ADDENDUM 01

DATE 02.04.23
 PROJECT NO. 2154
 PROJECT WEST FIELD SR. SEMINARY
 FROM STUDIO 333 ARCHITECTS

This Addendum forms a part of the Contract Documents and modifies the original Bidding Documents dated 01.25.23, as noted below. Acknowledge receipt of this Addendum in the space provided on the Bid Form. Failure to do so may subject the Bidder to disqualification.
This Addendum consists of 2 pages and the attached Drawing Sheets SD1.1, CE1.1, CE2.1, CE3.1, CE4.1, CE5.2, L201, A1.3, A5.1, A5.11, EP101, EP102, EE501, ES101,

1 2ND LEVEL POWER PLAN
SCALE: 1/8" = 1'-0"

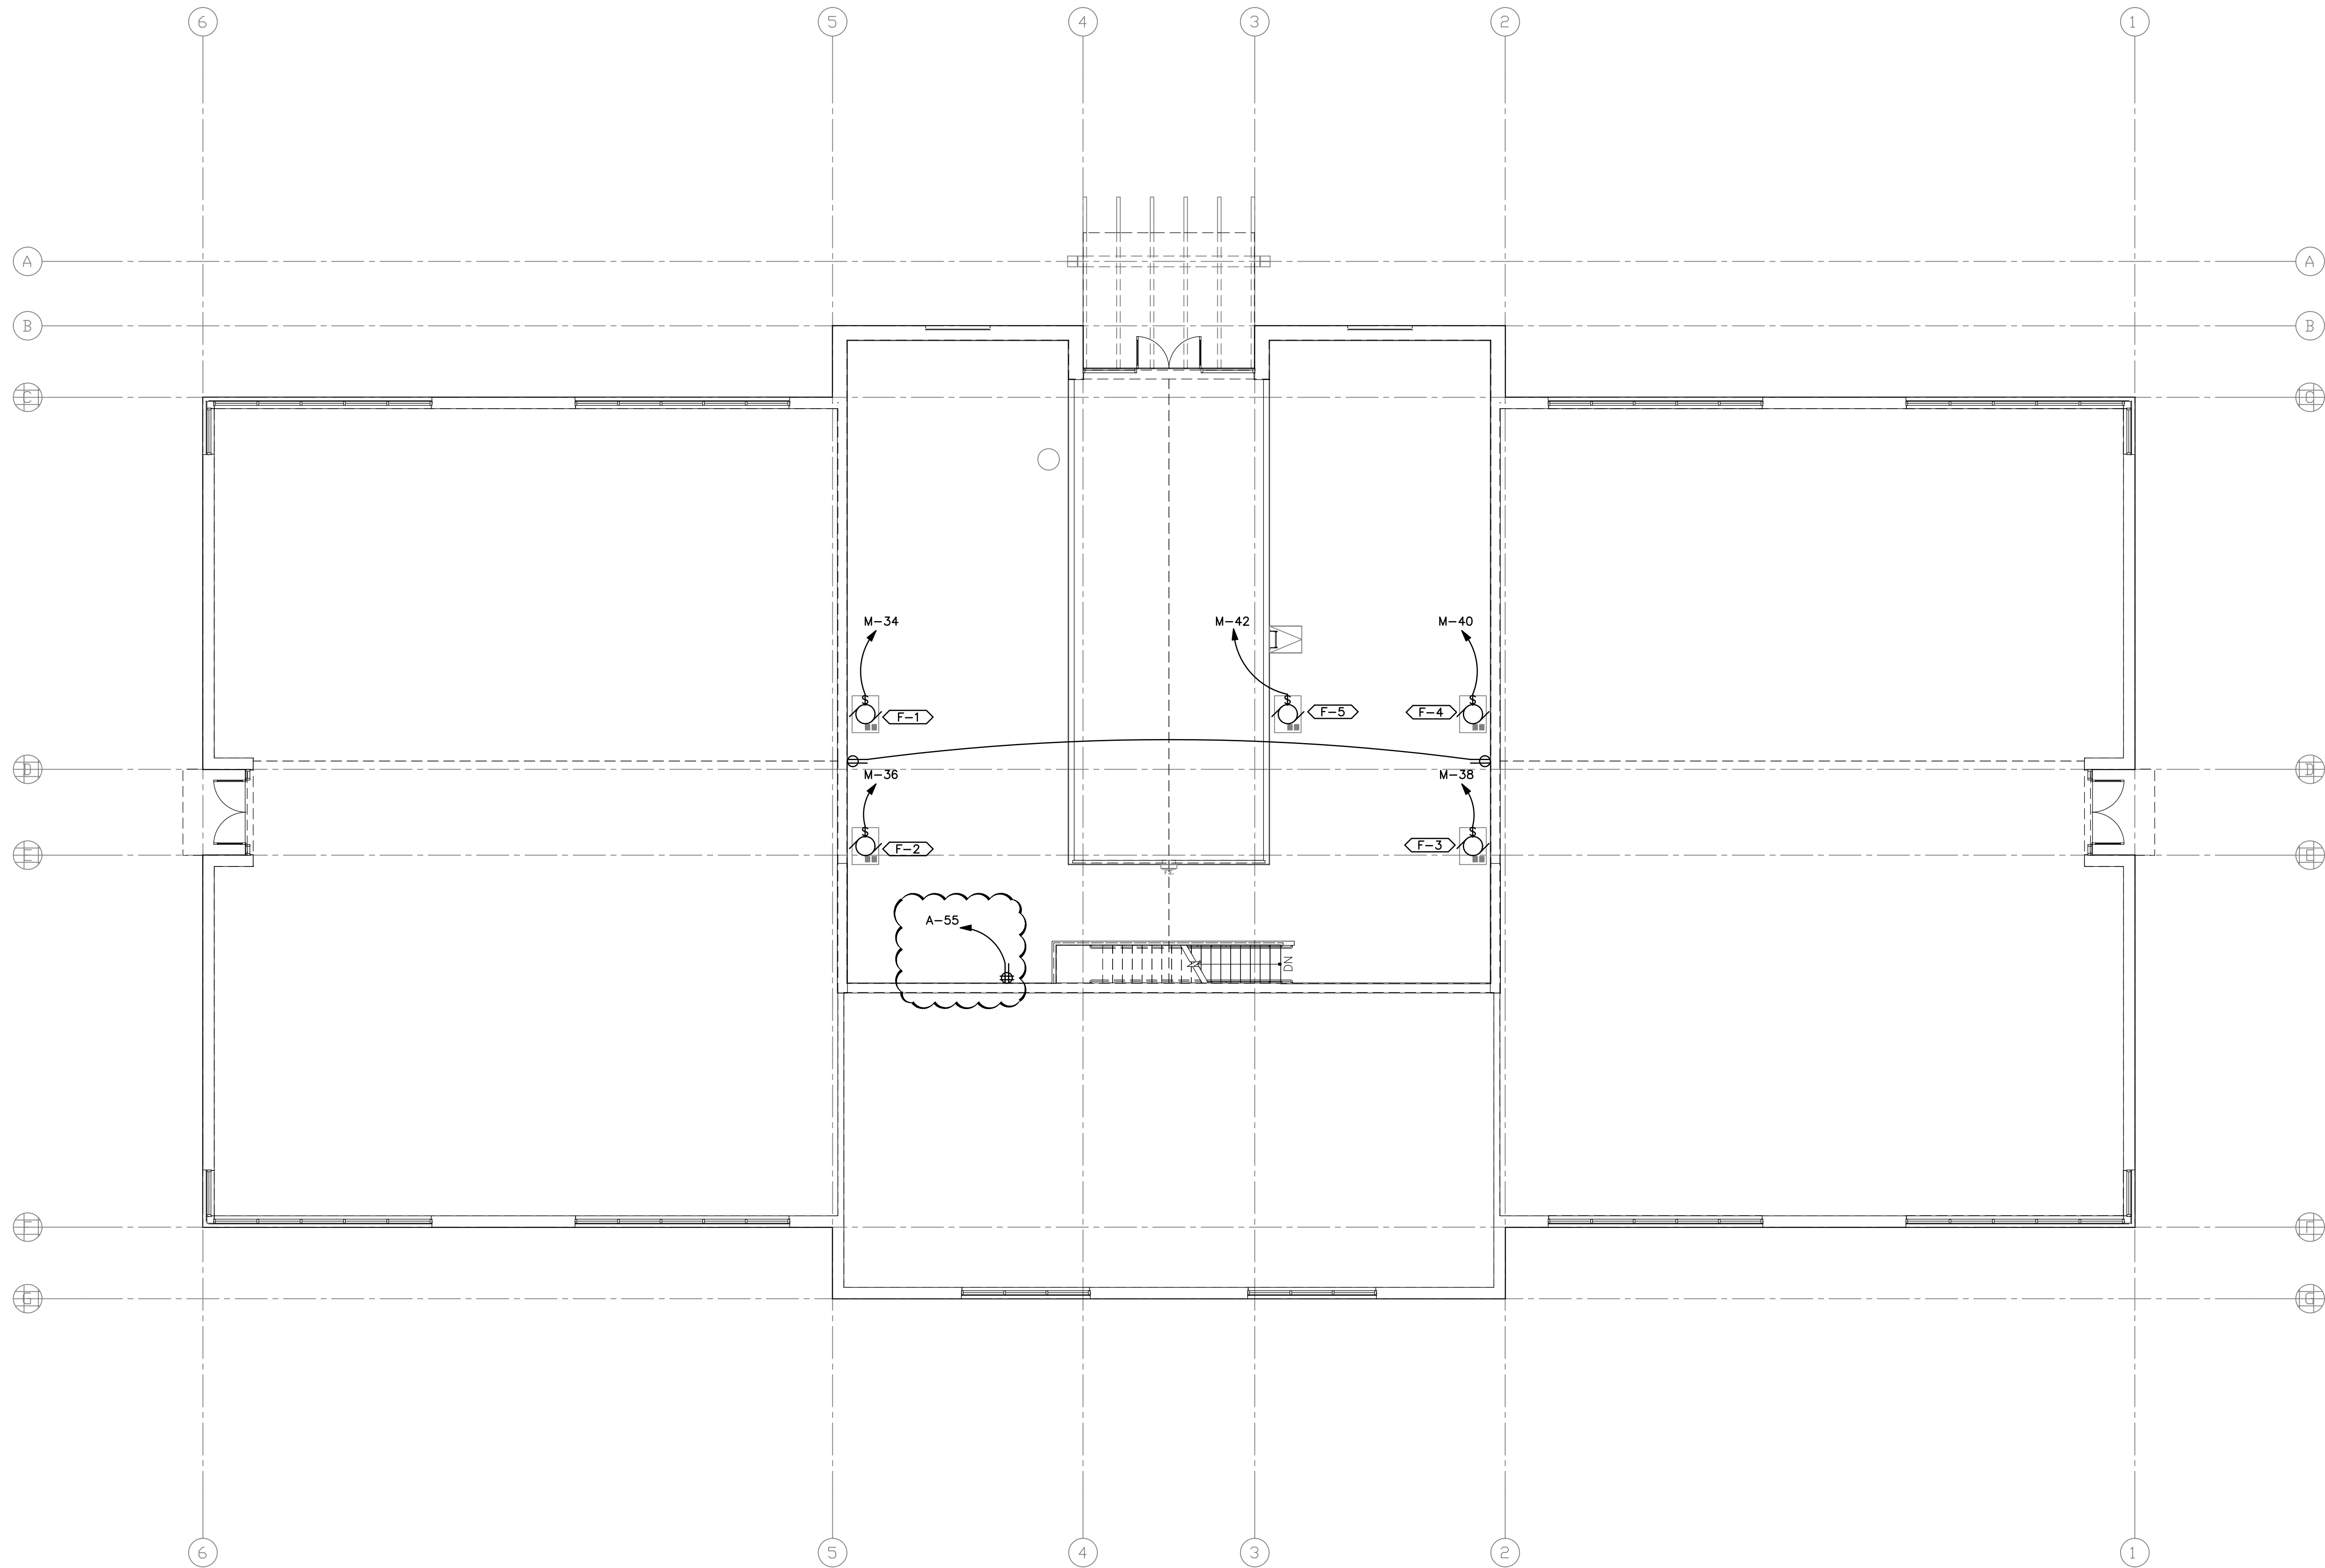
- a. Added 4 plex outlet on dedicated circuit at phone board
- 13. EE501 - SITE ELECTRICAL DETAILS:
 - a. Added sheet to show transformer pad detail
- 14. ES101 - ELECTRICAL SITE PLAN:

ELECTRICAL SITE PLAN

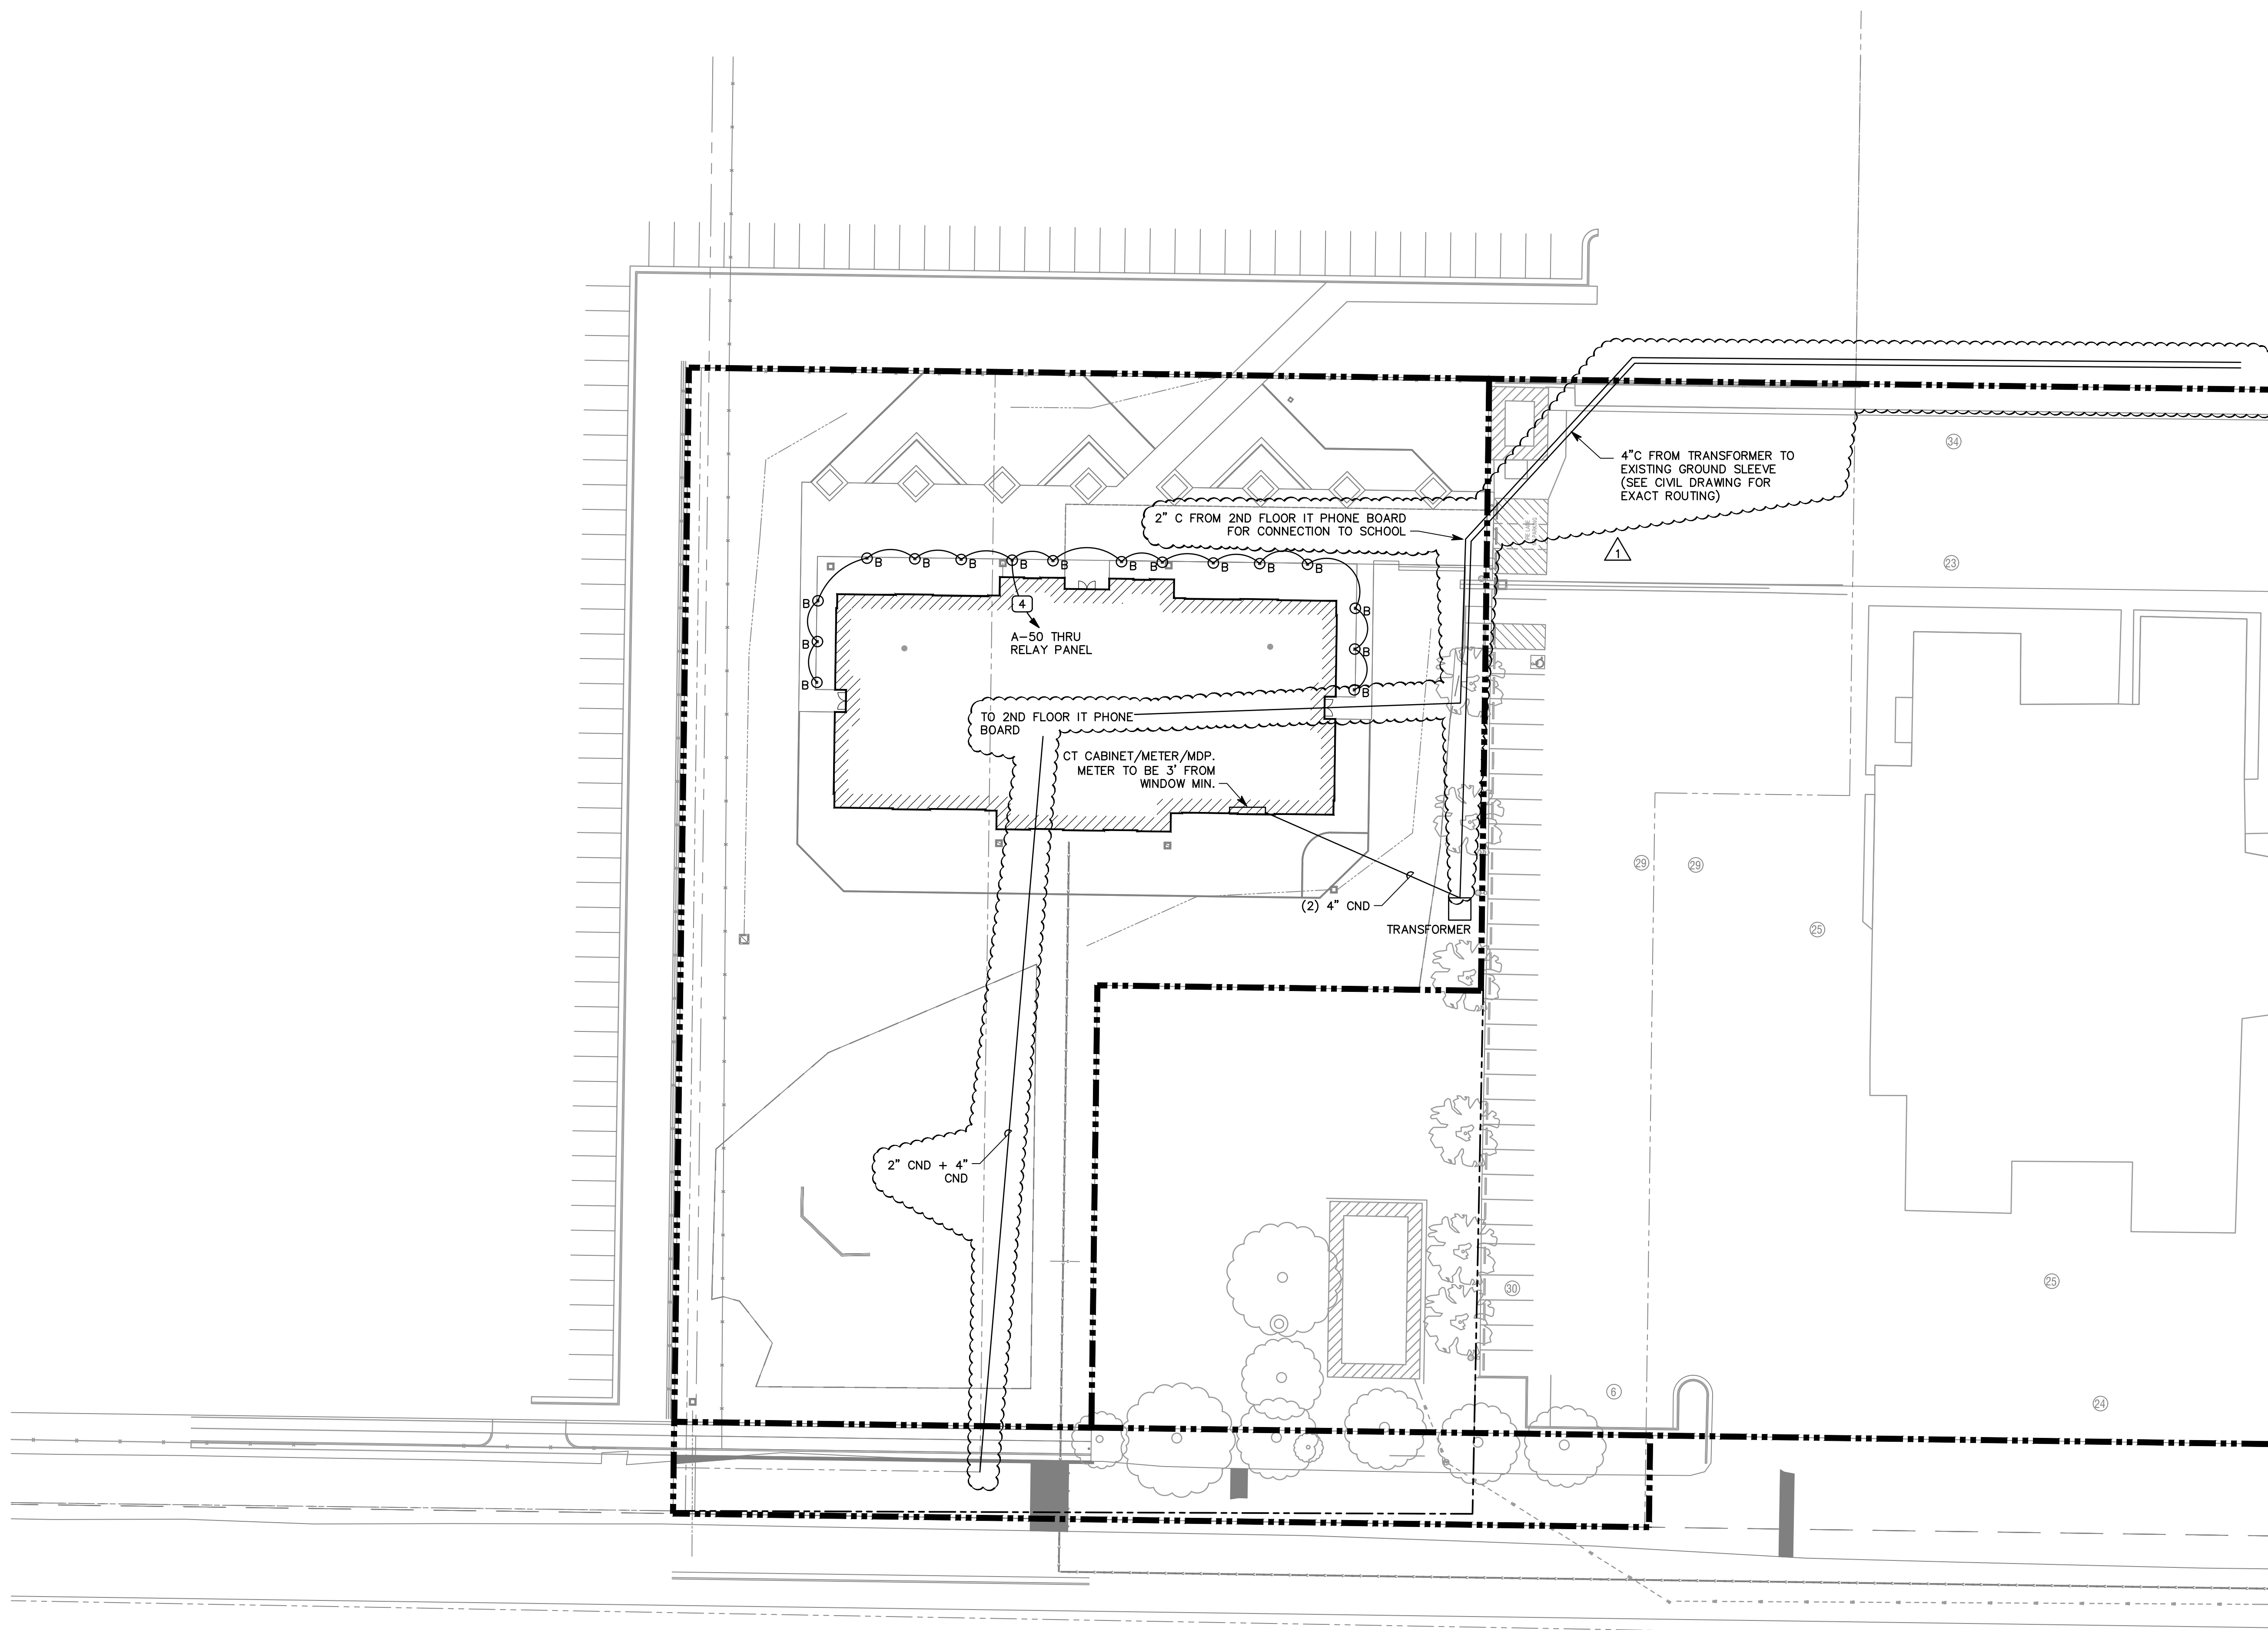
- 7. Sheets L201 - IRRIGATION PLAN and ES101 - ELECTRICAL SITE PLAN:
 - a. Relocate the existing Weather Trak Sprinkler Controller from the existing pavilion structure to the back of the seminary building near the electrical equipment.

- a. Added primary voltage conduit from transformer to ground sleeve. Added 4"+2" conduit for data conduits. Added 2" conduit for school bell system tie-in.
